This email thread relates to a comment that will be discussed in San Francisco during Qbf sponsor ballot comment resolution.

From: ao.ting@zte.com.cn [mailto:ao.ting@zte.com.cn]
Sent: Tuesday, May 17, 2011 10:44 PM
To: Robert sultan; panagiotis.saltsidis@ERICSSON.COM
Cc: shaddock@STANFORDALUMNI.ORG
Subject: One issue about 802.1Qbf

Figure 20-8—MEP Traffic Field Mismatch state machine

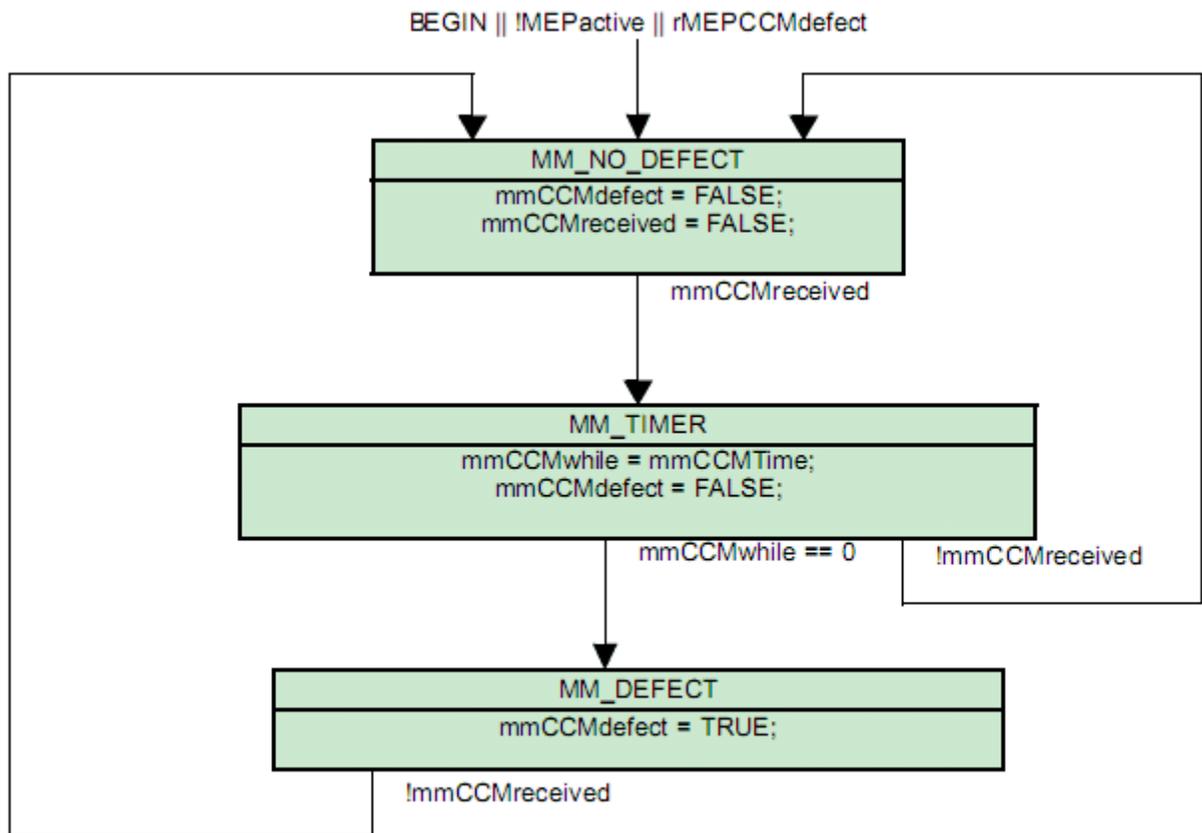
And in 802.1Qbf, we re-use the mismatch mistake state machine Figure 20-8. In the figure, there is a variable `mmCCMdefect` which is set to TRUE when the `mmCCMwhile=0` and `mmCCMreceived=1`. So in this figure, we know that the **mmCCMdefect** is the variable in infrastructure segment MEP.

But we only define the **mmCCMdefect** in 802.1Qay:

A Boolean flag set and cleared by the MEP Mismatch state machines to indicate that one or more CCMs with Traffic fields not matching the **presentTraffic** (20.9.8) has been received, over a period that is 3.5 times the configured CCM transmission rate.

Here **presentTraffic** is variable in PBB-TE MEP.

So I think the issue is in 802.1Qbf, we hope the **mmCCMdefect** is applicable to

infrastructure segment MEP. But we missed defining mmCCMdefect in 802.1Qbf.

My suggestion is to add the sub-clause 20.25.2 in 802.1Qbf as following:

20.25.2 **mmCCMdefect**

A Boolean flag set and cleared by the **PBB-TE MEP Mismatch** state machines to indicate that one or more CCMs with Traffic fields not matching the presentTraffic (20.9.8) has been received, **or by infrastructure segment MEP mismatch state machines to indicate that one or more CCMs with Traffic fields not matching ISpresentTraffic (20.9.10) has been received**, over a period that is 3.5 times the configured CCM transmission rate.
